PARTS LIST FOR MODEL FATHOM SD 40
REEL PART NO. 1238446

Model: FTHSD40 FATHOM 40 Star Drag

NOTE: Many of www.pennparts.com schematics include changes that were either made by Penn, or errors found and corrected by our parts dept.
SBT Ver. 073016 (Based on Penn's Rev 4, 10/31/14)

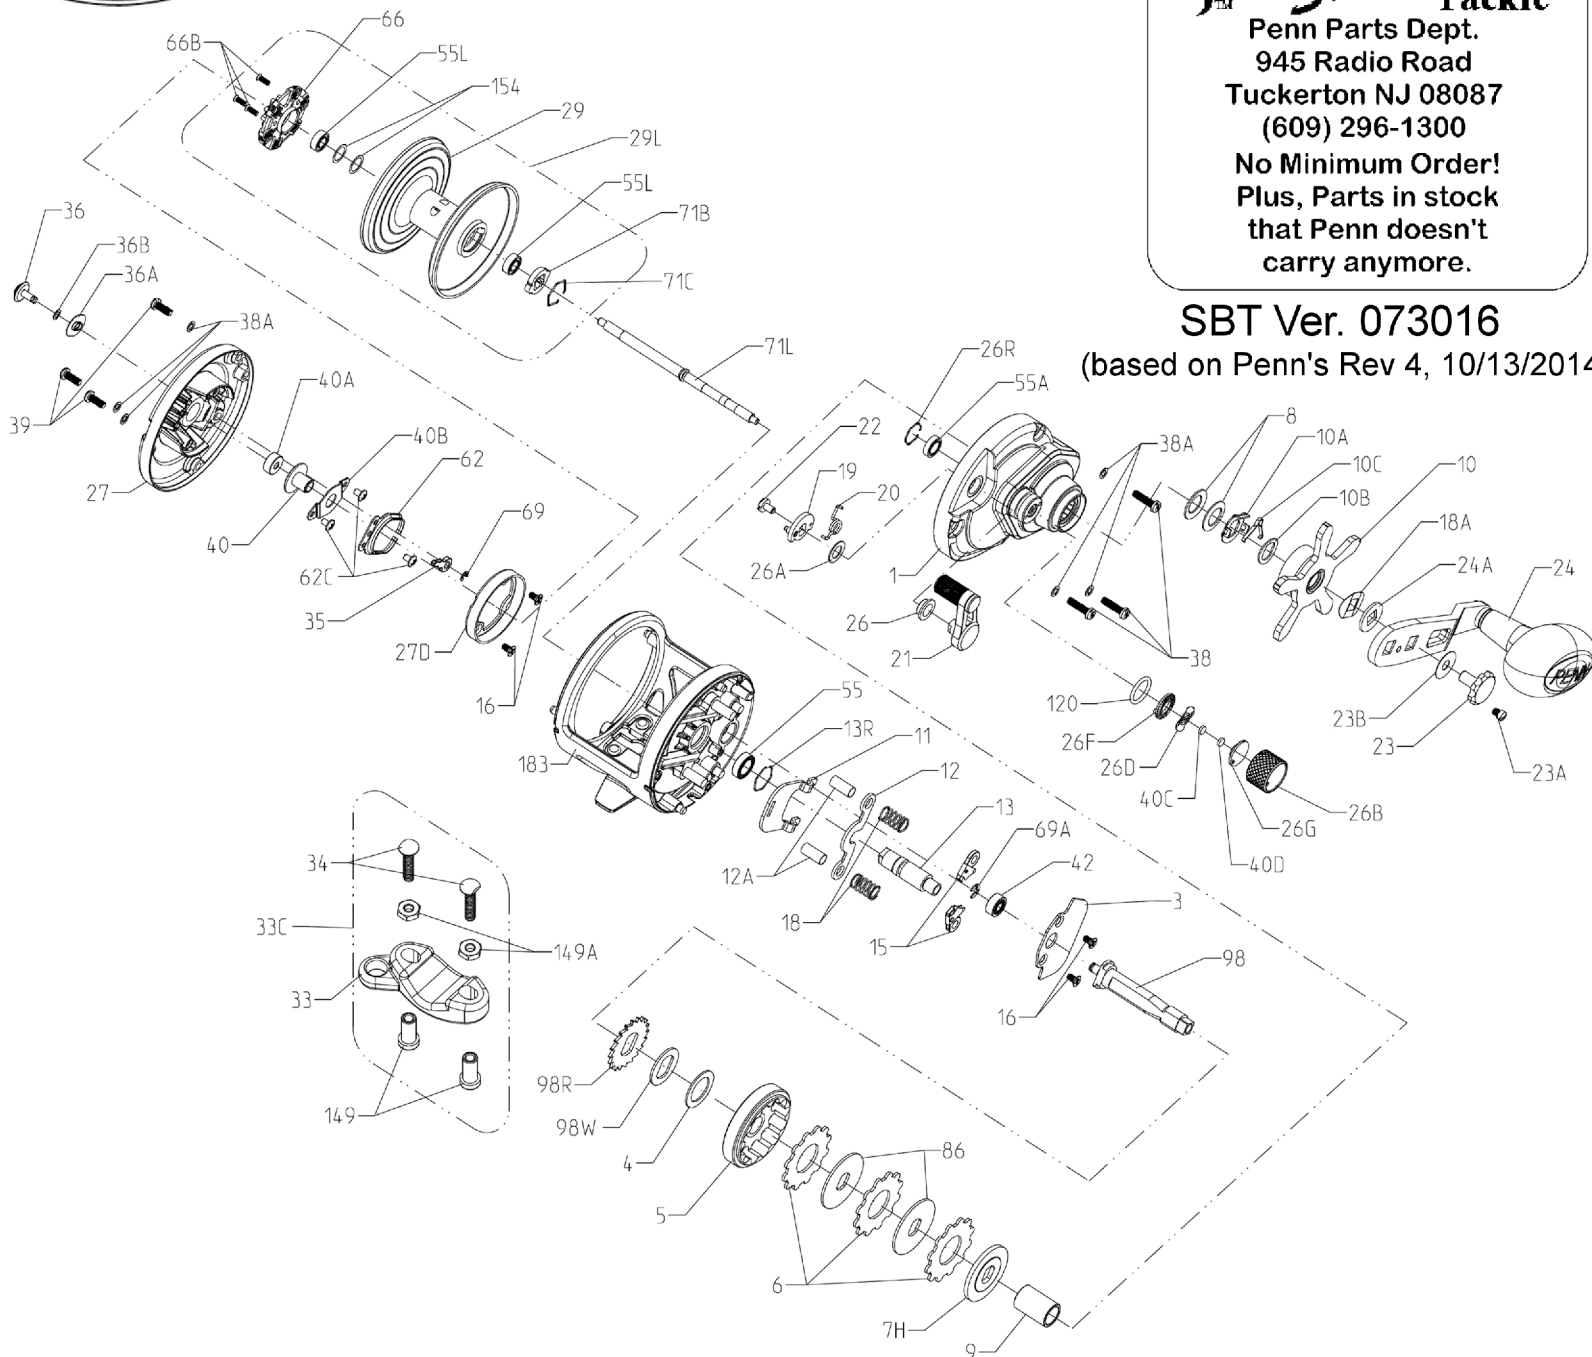
4 1180775 4-349 FIBER WASHER (Rev 0 Schematic typo had listed 4-60, but this was incorrect)

BELOW PENN CHANGED THE DESIGN ON LATER MANUFACTURING RUNS:

12 1181271 12-555 PINION YOKE (brass)
12A 1208062 12A-FTH20LW YOKE POST BUSHING (2 REQUIRED)

Opening in yoke measures .263" and brass yoke is .043" thick

Diameter of screw holes was ALSO changed, so if changing to the yoke, you must also change the bushings.

**Increased thickness in the yoke in later reels sits better/snugger in the groove of the #13 pinion, so there is less slop in shifting eccentric

12 1318919 12-FTHSD12 PINION YOKE (stainless)
12A 1372972 12A-FTHSD12 YOKE POST BUSHING (2 REQUIRED)

Opening in yoke measures .253" and stainless? yoke is .063" thick**
